Panel Report

Darebin Planning Scheme Amendment C161

Fairfield Village

3 December 2018

Figure 6 **Alternate Fairfield Village DDO precincts**

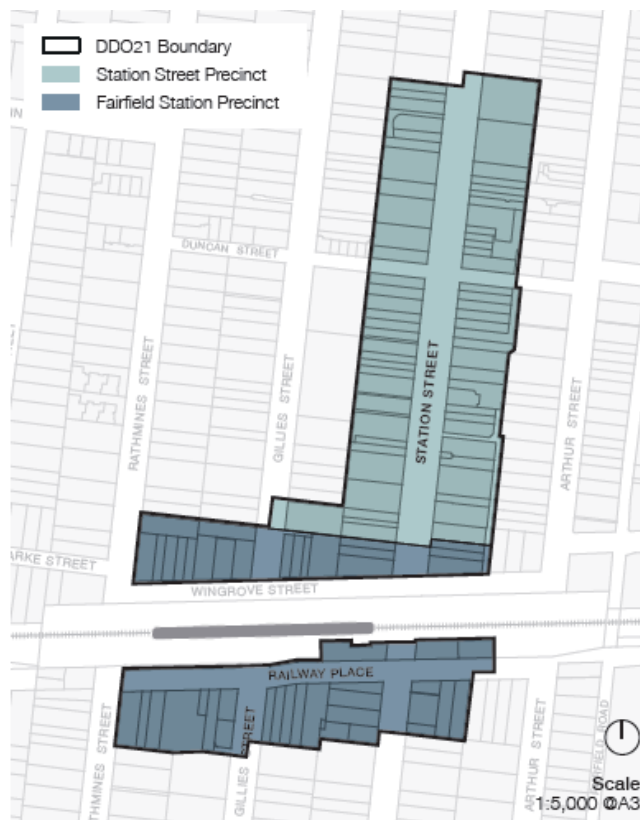
Mr Blades' evidence was generally in accordance with this analysis, although he included additional precinct-based analysis. Mr Blades' evidence suggested that Council's precinct distinction was based primarily on heritage considerations and did not recognise the distinct character differences between Station Street and streets adjacent to the station. Mr Blades' analysis identified two distinct character precincts (Figure 6):

Council did not support this position. Ms Bell indicated in that Mr Blades' precinct assessment did not respond to key character elements or heritage. Ms Bell's evidence did however recommend the inclusion of the properties at 129-135 Station Street in Area 1 to create a distinct edge to the two areas and to ensure that different sides of Station Street south of Duncan Street did not have different height provisions. Council indicated its acceptance of this recommendation in its revised DDO21.

Mr Walker indicated that this Area change potentially represented a transformation to the Amendment and that affected land-owners had not had the opportunity to consider the potential impacts of this change.

Figure 7 Blade recommendations for Street wall height and setbacks

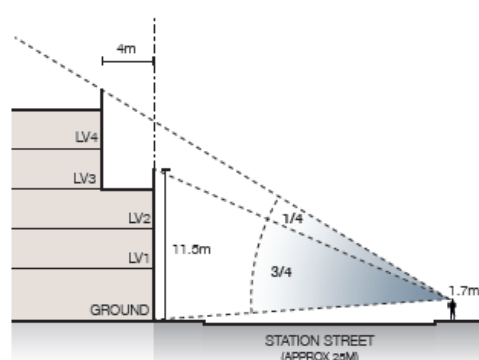
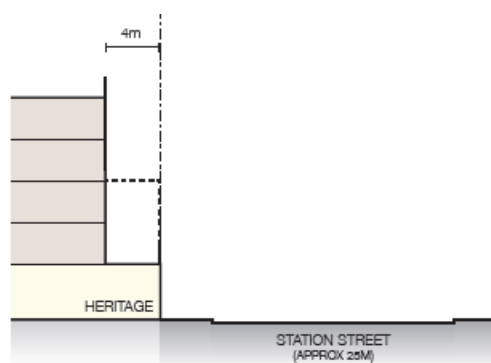
Mr Blades proposed, that rather than the stepped setback approach adopted by Council, a quarter/ three-quarter upper level setback be applied to Station Street with a minimum upper level setback of 4m and a minimum 4m upper level street level for all sites adjacent of the station and rail corridor (refer Figure 7). Mr Blades suggested this was a superior approach to the sight-line approach used by Council.

Figure 8 Bell recommendations for street wall and setbacks

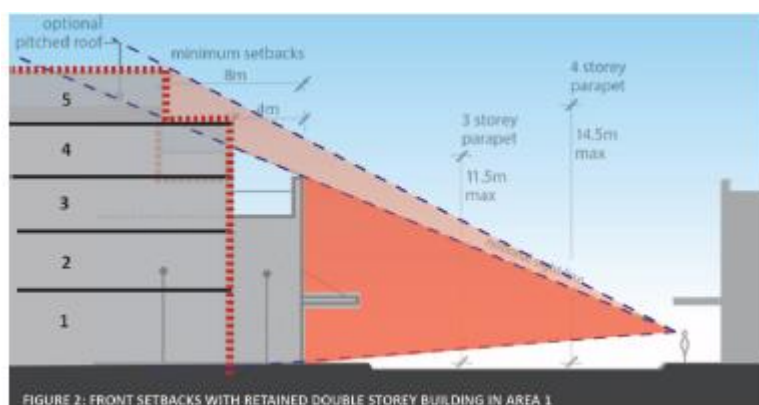
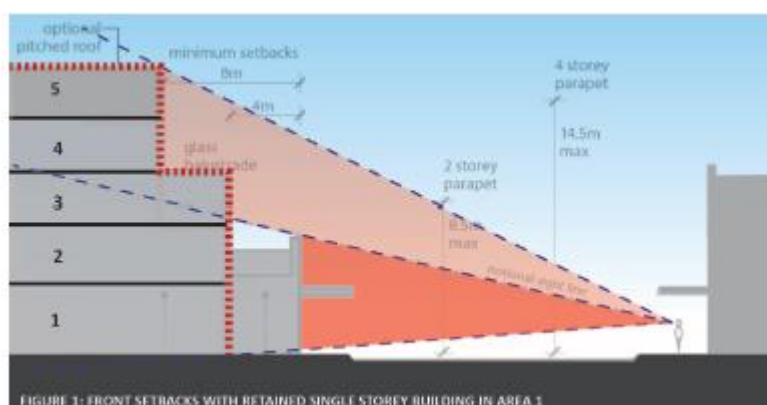
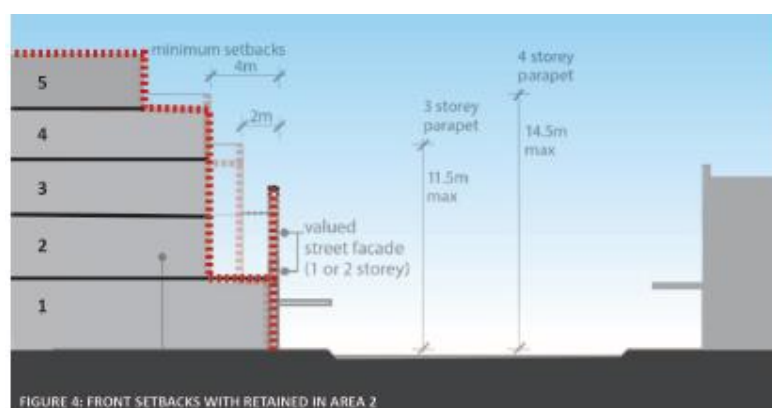
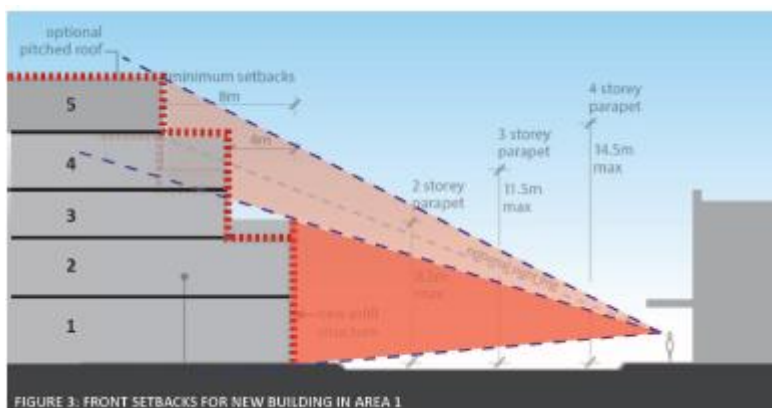
Ms Bell recommended changes to the wall height and setback requirements (refer Figure 8):

- for single storey buildings retained in Area 1 - a 4m setback up to the third storey and 8m up to the fifth storey
- for double storey buildings retained in Area 1 - a 4m setback up to the fourth storey and 8m at the fifth storey
- for a new building with a 8.5m street wall in Area 1 - a 4m setback up to the fourth storey and 8m at the fifth storey
- for a building retained in Area 2 - a 4m setback for the second, third and fourth storey and 8m at the fifth storey
- retaining the existing upper level setbacks for new buildings in Area 2.

The Panel broadly support Ms Bell's recommendations to replace the Figures 1 to 4 in DDO21 with the those included in her evidence. The Panel notes that the street wall height and setback requirements as proposed in DDO21 can be varied with a permit. This is appropriate to enable a contextual response to site size and location.

- The street wall height requirements as exhibited are appropriate.
- The front setback requirements as exhibited should be replaced with those included in Ms Bell's evidence.
- Figure 4 for Area 2 should be deleted if the valued street facades sites are removed from Area 2.

Figure 9 Rear setback requirement

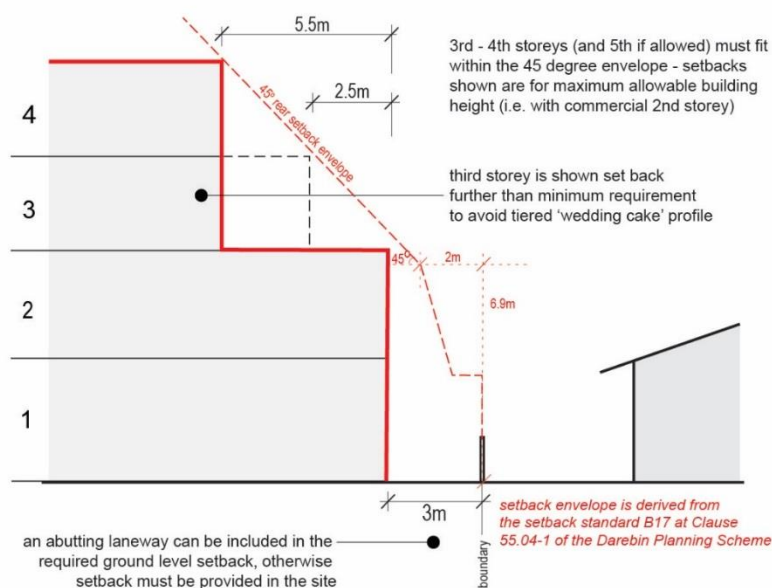
The rear setbacks and interface requirements provide for a 3m rear setback at first and second floors and further setback at higher storeys within a 45 degree envelope as shown in Figure 9.

Ms Bell's evidence supported the rear setback requirement but suggested that Figure 7 of DDO21 identify the fifth floor.

Figure 4: Front setbacks with retained valued street facade in Area 2

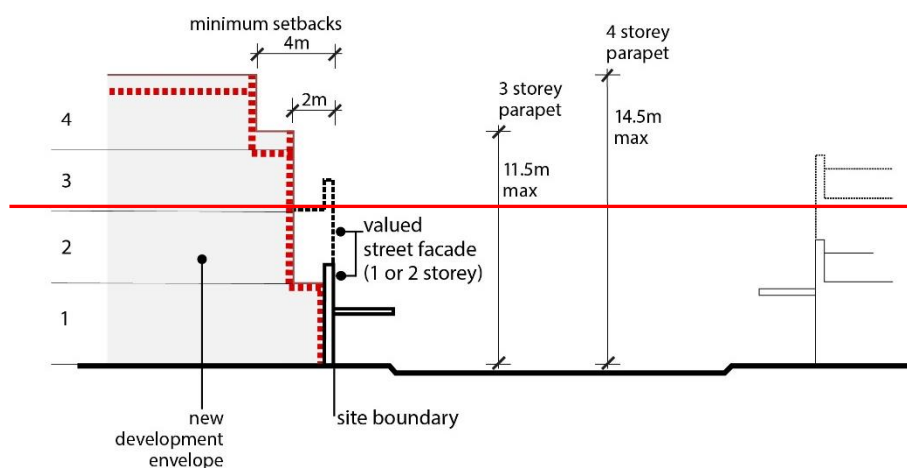
The Panel notes that the removal of valued street facades from Area 2 as recommended would result in DDO21 Figure 4 being obsolete.

Figure 4 to be updated to Julia Bell's recommendation
